Appliance Standards Awareness Project  
American Council for an Energy-Efficient Economy  
Alliance to Save Energy  
Natural Resources Defense Council  
Northwest Power and Conservation Council

May 16, 2014

**RE: Docket Number EERE-2010-BT-STD-0037/ RIN 1904-AC39: Notice of Proposed Rulemaking for Automatic Commercial Ice Makers**

## Appendix A<sup>20</sup>

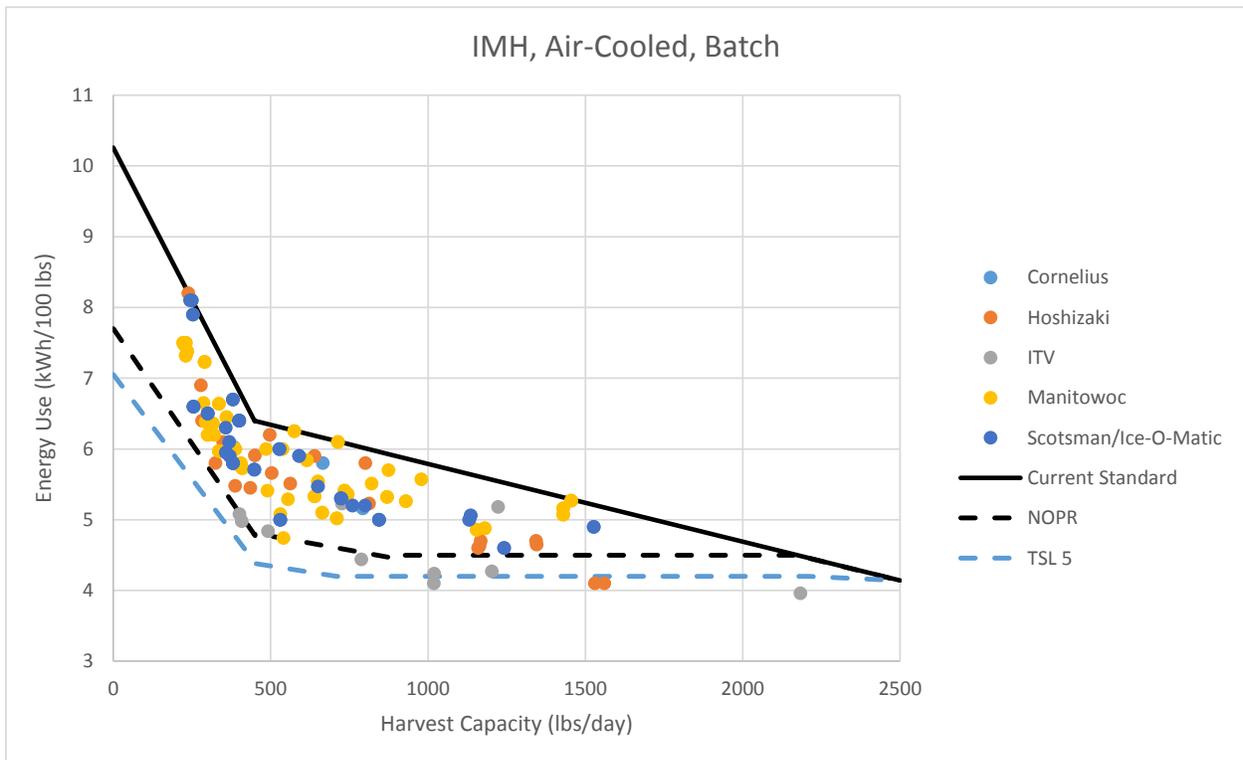
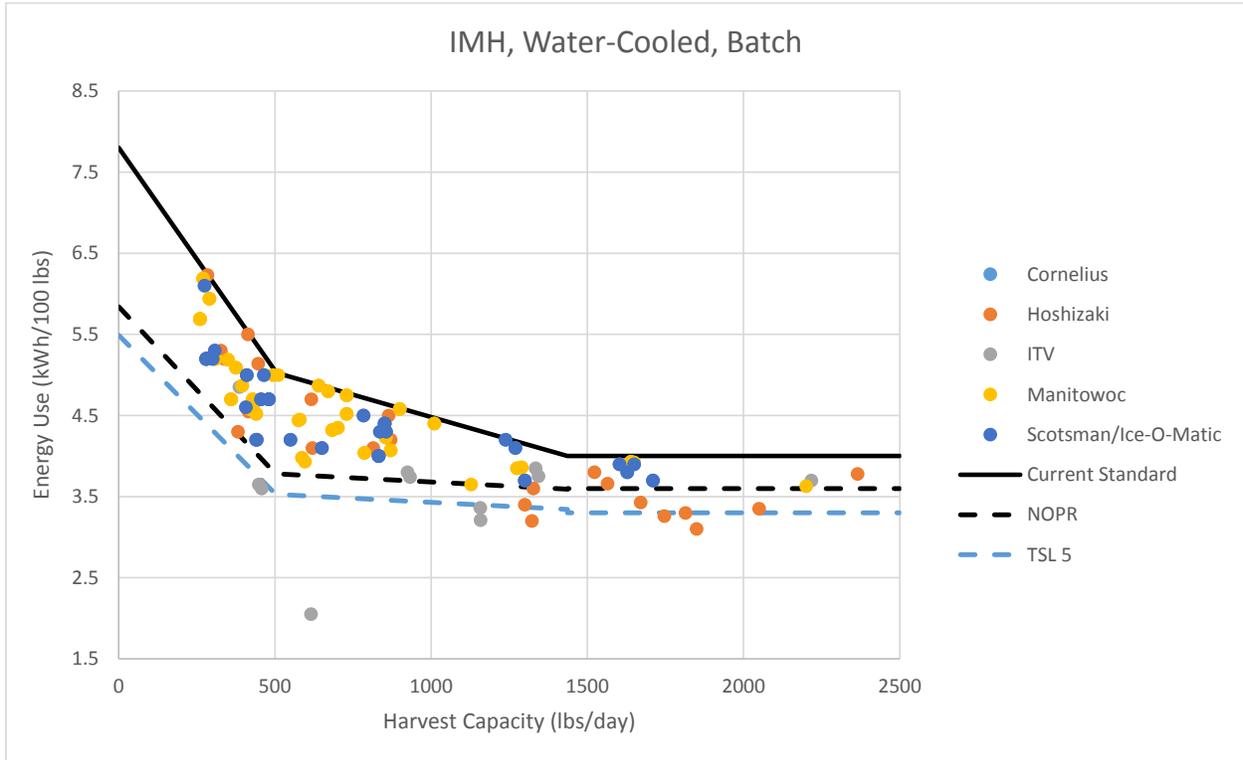
Certification Compliance Database, it appears that the “small business manufacturer” is ITV (see Appendix A). As shown in the graphs in Appendix A, while it appears as though Hoshizaki and ITV are the only manufacturers with current models that meet TSLs 4 and 5 for ice-making head (IMH) air- and water-cooled batch equipment and self-contained (SCU) water-cooled batch equipment, the other two major manufacturers, Manitowoc and Scotsman/Ice-O-Matic, have models that meet TSLs 4 and 5 for other equipment classes. Specifically, Manitowoc has equipment that meets TSLs 4 and 5 for remote-condensing (RCU) air-cooled batch equipment (both remote-compressor and non-remote-compressor types) and SCU air-cooled batch equipment, and Scotsman/Ice-O-Matic has equipment that meets TSLs 4 and 5 for RCU (non-remote-compressor) air-cooled batch equipment. In sum, the data show that all three major manufacturers (Hoshizaki, Manitowoc, and Scotsman/Ice-O-Matic) in addition to one small manufacturer (ITV) have models available today in one or more batch-type equipment classes that already meet TSLs 4 and 5.
